Access Compliance Report Public Rights-of-Way (Curb Ramps)

Intersection ID: 8611 Main Street: BROOKSHIRE BV **Cross Street: CENTRE_ST** Location: W ADA ID: 56EE17D2C2CA Ramp Type: Perp Initial Pass/Fail: Fail **Overall Compliance: No Severity Score:** 8.75

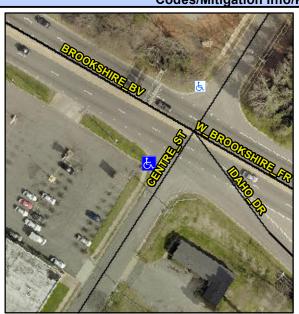
Possible Solutions: Remove & Replace Entire Ramp. Surveyor Notes: N/A PROW/ADA: Not Found, R304.5.1

Field Measurements/Component Compliance						
	Compliance Description		Data	Compliance Description		Data
	N/A	Ramp Length (in)	61.0	Yes	Ramp Slope (%)	5.9
	No	Ramp Width (in)	47.5	Yes	Ramp XSlope (%)	0.3
	N/A	Flare Type LT	N/A	N/A	Flare Type RT	N/A
	N/A	Flare Slope LT (%)	N/A	N/A	Flare Slope RT (%)	N/A
	N/A	Flare Traversable LT?	N/A	N/A	Flare Traversable RT?	N/A
	N/A	Landing Length (in)	N/A	N/A	DWS Provided?	N/A
	N/A	Landing Width (in)	N/A	N/A	DWS Contrast?	N/A
	N/A	Landing Slope (%)	N/A	N/A	DWS Length (in)	N/A
	N/A	Landing X Slope (%)	N/A	N/A	DWS Full Width?	N/A
	N/A	Landing Curb? (Y/N)	N/A	N/A	DWS Offset (in)	N/A
	N/A	Shared Landing?	N/A			
	N/A	Gutter Ponding?	N/A	N/A	Gutter Slope (%)	N/A
	N/A	Gutter Lip Ht (in)	0.5	N/A	Gutter X Slope (%)	N/A
	N/A	Painted X Walk1?	No	N/A	Painted X Walk2?	N/A
		X Walk 1 Direction	То Е		X Walk 2 Direction	N/A
	N/A	X Walk 1 Width (in)	N/A	N/A	X Walk 2 Width (in)	N/A
		X Walk 1 Slope (%)	0.3		X Walk 2 Slope (%)	N/A
